Ageas Bowl Masterplan

Transport Assessment Addendum

Project no. 70073579

Our Ref. No. TAA-001

Figure 3-1 - Accident Data

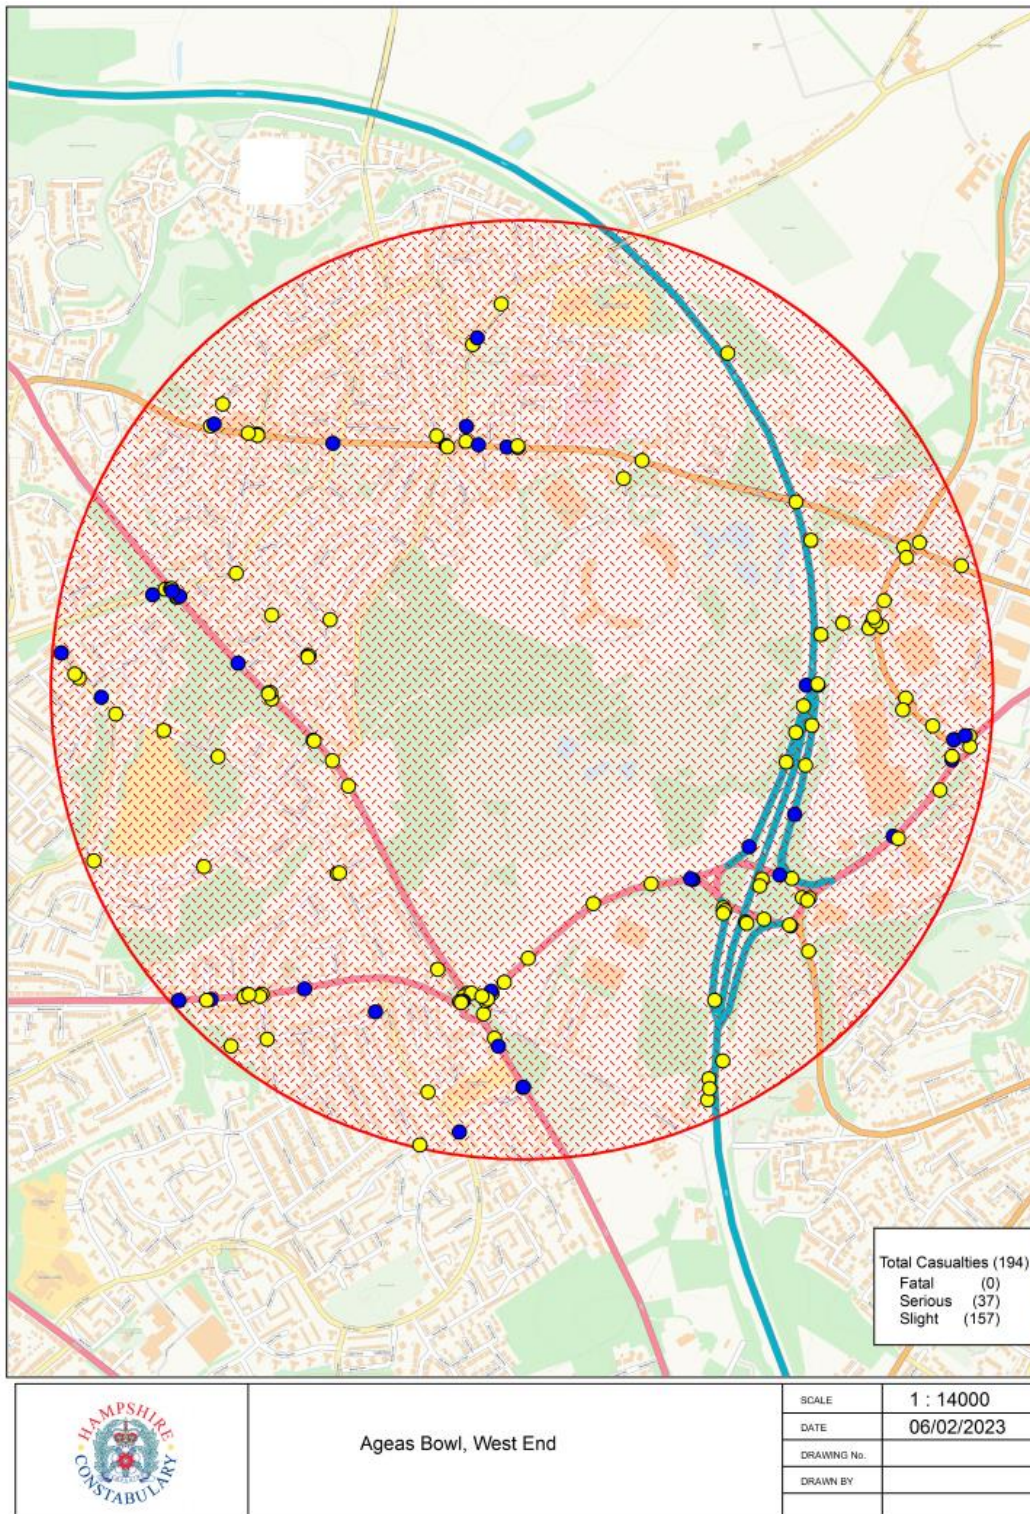
- 3.1.1. The HCC Highways response raised a query regarding the accident data presented as part of the application Transport Assessment (TA) being out of date. The full details of the comment are presented below.
- 3.1.2. *A PIA (Personal Injury Accident) data has been provided, from 1st May 2015 to 30th April 2020, obtained from Hampshire constabulary. The TA states that in November 2021 more recent accident data was requested, however Hampshire Constabulary confirmed that the data provided is the most recent dataset. However, this request is almost a year old, and the applicant should confirm if there is more recent data available.*

- 3.2.1. WSP have received updated Collision Data from Hampshire Constabulary, with a review of the Collision Data detailed below.

- 3.2.2. Based upon the analysis of Personal Injury Accident (PIA) data received from Hampshire Constabulary for the latest available 5-year period (01/10/2017 – 30/09/2022) a total of 194 PIAs occurred with 37 being classified as 'Serious' (19%) and 157 classified as 'Slight' (81%). No fatal accidents were recorded within the study period or area, for which a 1km buffer was used around the Site which incorporated all of the key local junctions identified. Approximately 11% of the recorded incidents involved at least one pedal cycle.
- 3.2.3. Figure 3-1 shows the location of the accidents that occurred in the study area during the most recent five year period.

- 3.2.4. Five cluster sites of accidents were identified at the following locations with a review of the data identifying the majority of the recorded accidents as being 'Slight':

- 3.2.5. A review of the causation factors at these cluster sites identified that the PIAs were caused by human error, with factors such as ‘failing to see’ and ‘careless/reckless/in a hurry’ being listed as opposed to issues within the operation/design of the highway network.

Figure 10-1 - Profile arrivals (T20 England Vs. India)

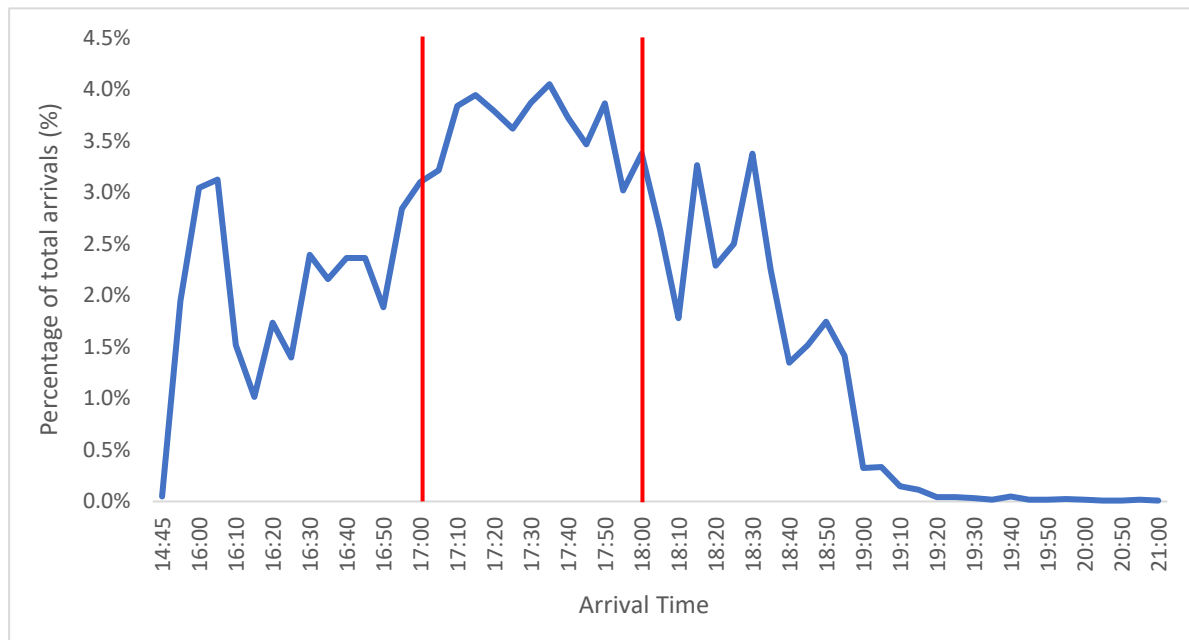
- *For One-Day International Matches occurring on a weekday up to 46.8% of event spectators are assumed to arrive in the AM peak period, and*
- *For Concerts or Twenty Twenty Cricket Matches up to 41% of event spectators are assumed to arrive in the PM peak period.*

Assuming the maximum car park capacity is 700, would result in 328 arrivals in the AM peak and 288 arrivals in the PM peak, with a 50/50 split of direction of travel. However, this is just an assumption, and the applicant should confirm if this is the worst-case scenario that has been used.”

10.4.2. As the only assessed scenario which took place on a weekday was the England vs. India match on 7/7/22. The full profile arrivals for this match are set out in table Figure 10-1.

10.4.3. As can be seen above, 43.5% of total arrivals occurred between the 17:00 and 18:00. This is marginally higher than 41% of event spectators which was assumed within the Transport Assessment for Twenty20 Cricket Matches. However, it is still lower than the assessed arrivals for One Day International matches. As such, the assessment undertaken within the Transport Assessment can be seen as robust and as representing a worst-case scenario.
